Mareeba Shire Council
65 Rankin Street
PO Box 154
Mareeba QLD 4880

**Response to Pre-Request for Information
2-4 Quill Street, Mareeba (OPW/21/0006)**

QUILL STREET LAND DEVELOPMENT

DRAWING REF	DRAINAGE EASEMENT																																	
DRAWING NO	160-001-SK09	SIZE A3	REVISION 1																															
1	15/05/23	INITIAL ISSUE																																
NO.	DATE	DESCRIPTION	DESIGN	APPROVED

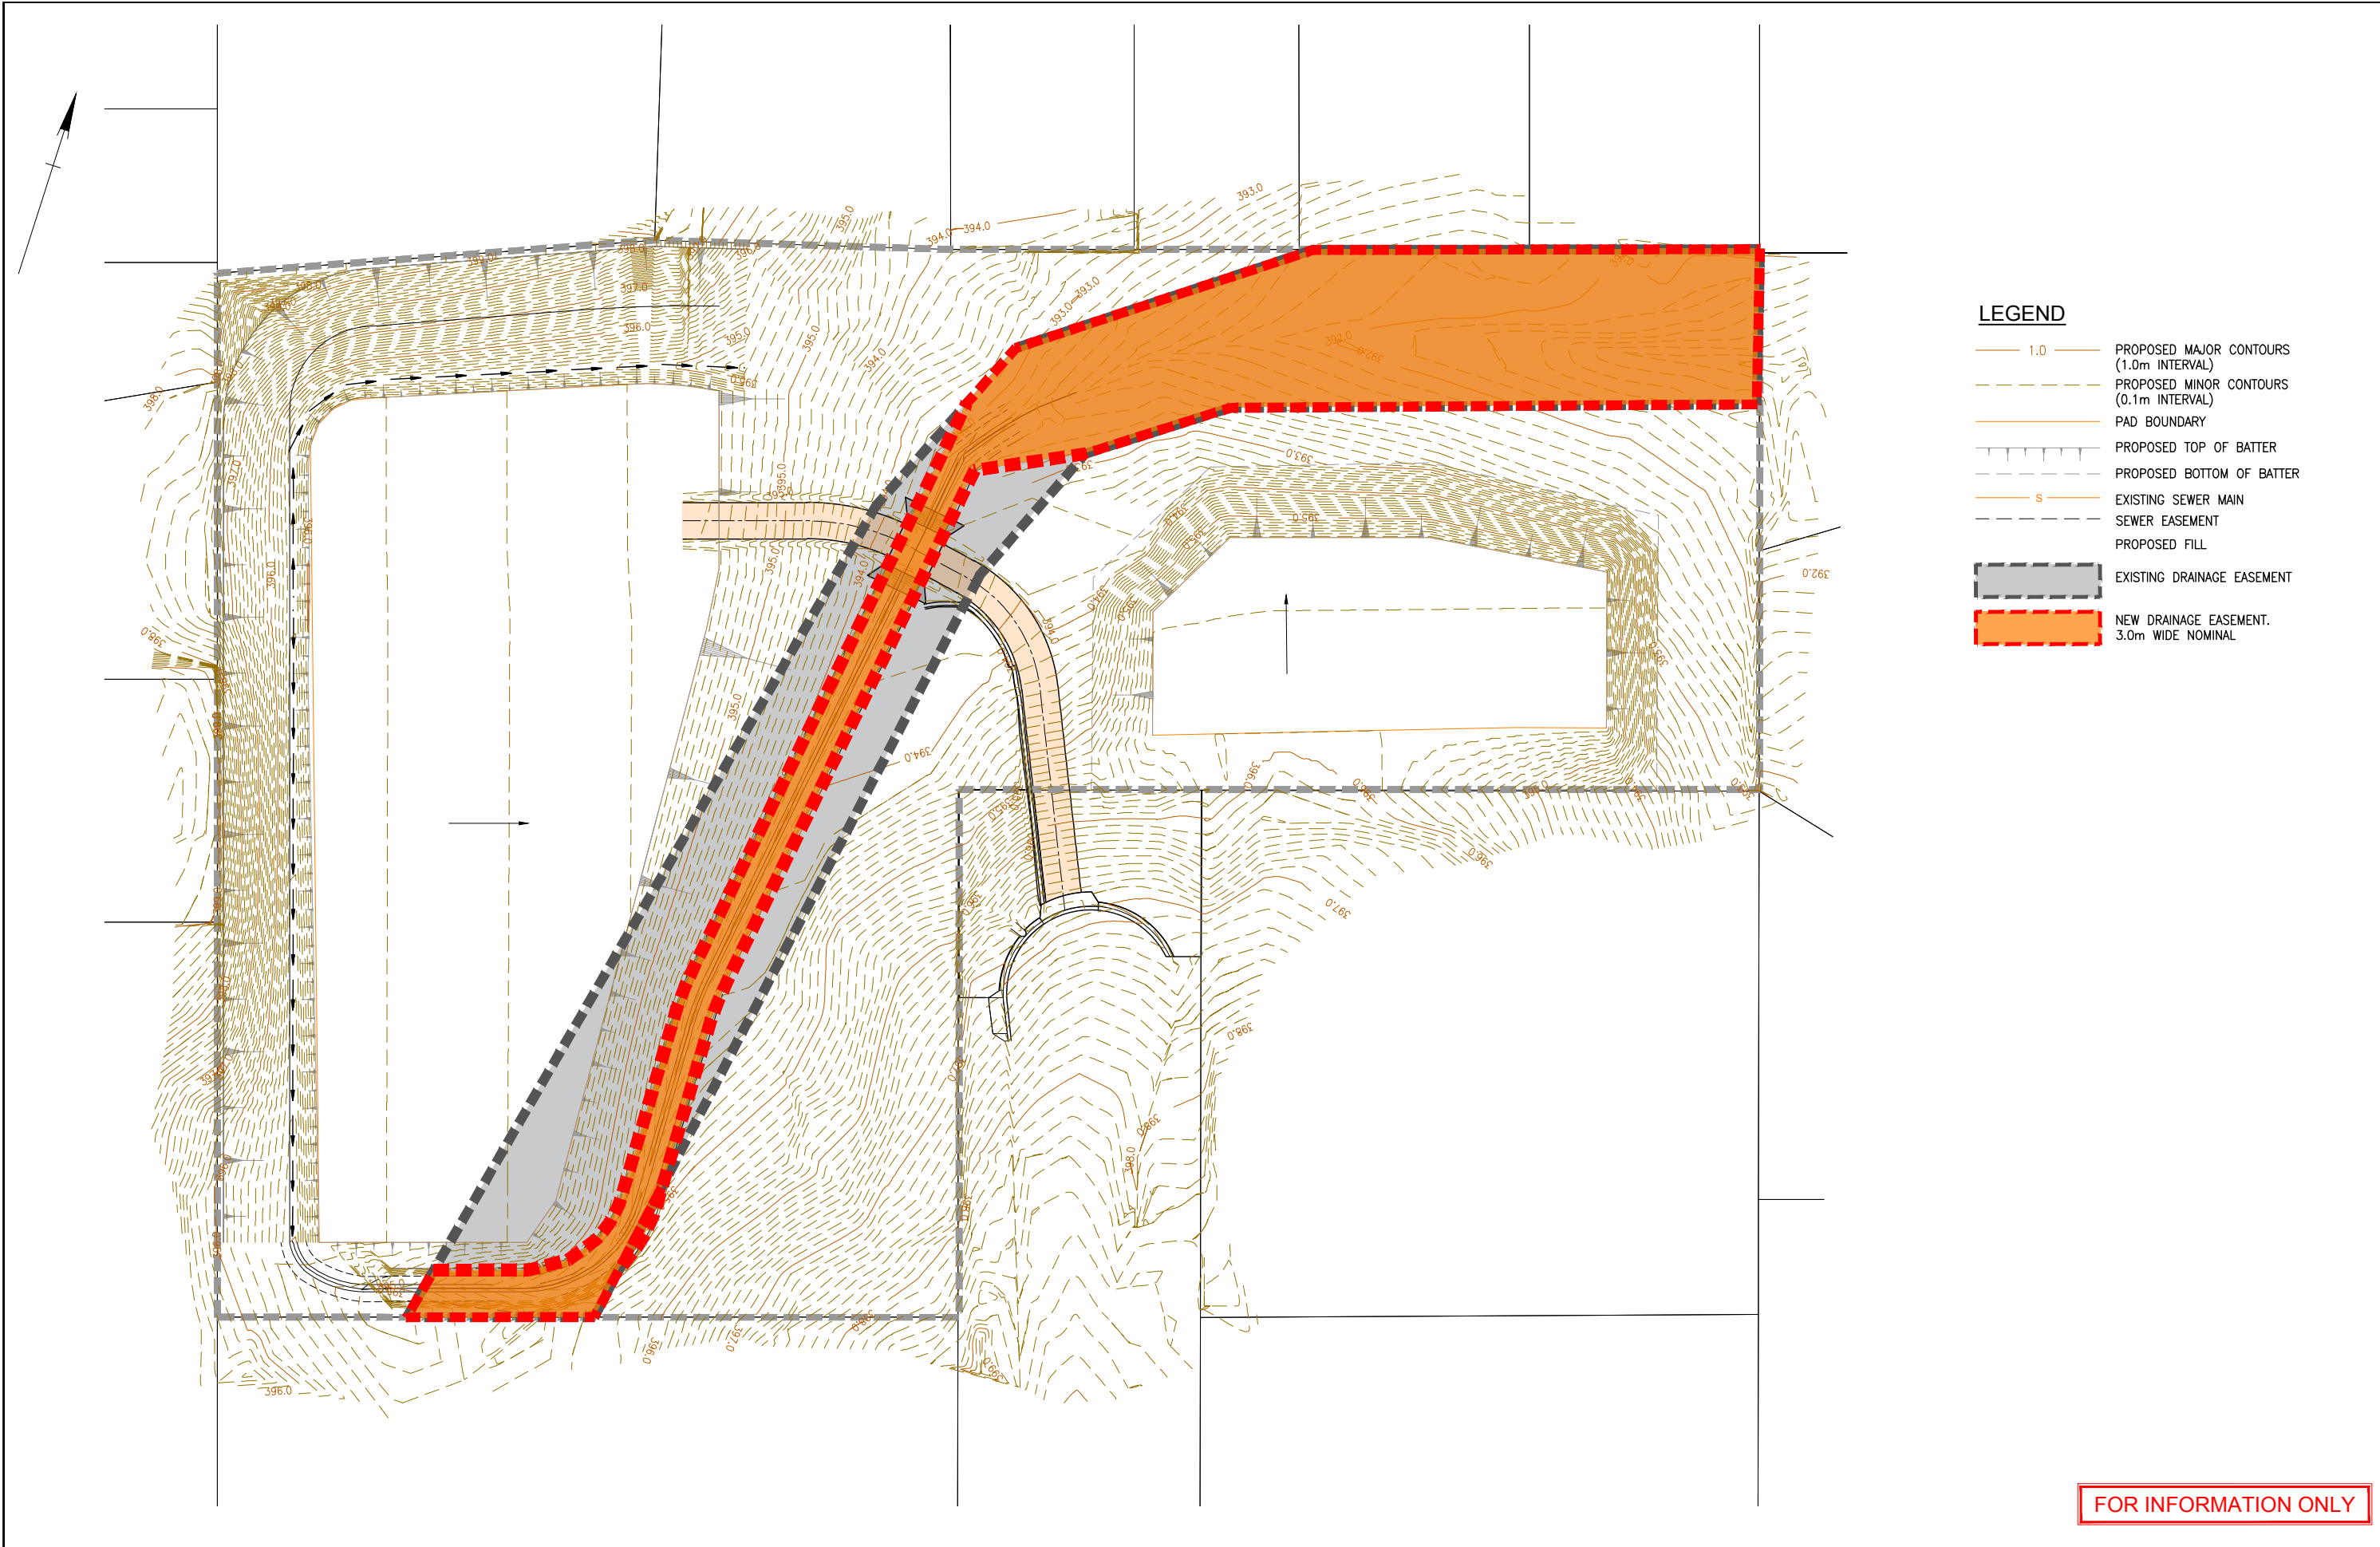
4. The drawings must be amended to show the location and extents of the existing drainage easement through the property.

No filling or retaining wall works for the building envelopes are to intrude into the drainage easement.

Advice Note: An approximate overlay of the easement from Queensland Globe data set appears to show the southern part of Building Pad 1 and a significant portion of the eastern batter to Building pad 1 encroaching into the easement.

5. The drawings must identify any proposed changes to the drainage easement to reflect the proposed additional drains nominated for construction under this application.

The southern corridor of the new drainage easement has been redirected and contained within the new drainage alignment. The previous drainage easement would have been created with the natural surface of the undeveloped land using the existing flow path and land profile. The engineered profile shows the Q100 will be contained within the 3.0m wide easement of the new alignment. See sketch drawing 160-001-SK09 rev 1.

The new alignment of the easement has been shown on sketch drawing 160-001-SK09 rev 1.

PROJECT REF		CONMAT PTY LTD	
DRAWING REF		QUILL STREET LAND DEVELOPMENT	
DRAWING NO		SEWER DEPTH ZONE OF INFLUENCE	
160-001-SK010		SIZE A3	REVISION A

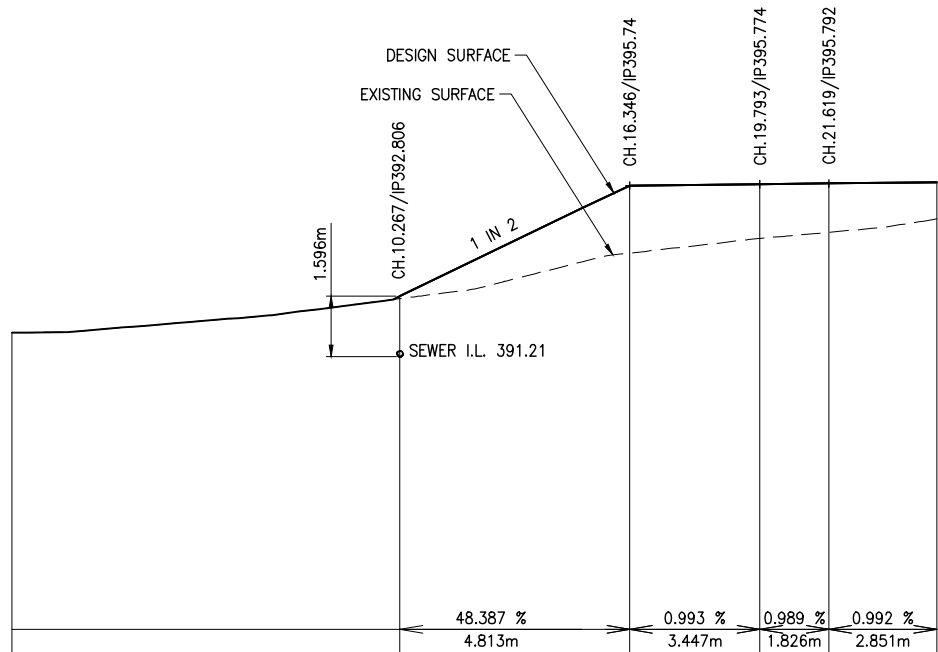
17. Provide a section through the Building Pad 2 fill platform and earth batter at the point closest to the sewer line. The section is to demonstrate the zone of influence for the sewer and confirm that the engineering solutions proposed ensure that the existing sewer main is not impacted by the new works. The details must also demonstrate that future maintenance of the sewer is not constrained by the new earthworks proposed.

That is; the sewer main must be able to be excavated in future without any special engineering solutions to prop or stabilise the proposed batter. If this cannot be achieved the design must be revised to achieve this sewer maintenance outcome.

The depth of excavation under the new battered surface to the sewer is 1.535m. No special engineering solutions should be required to excavate to this.
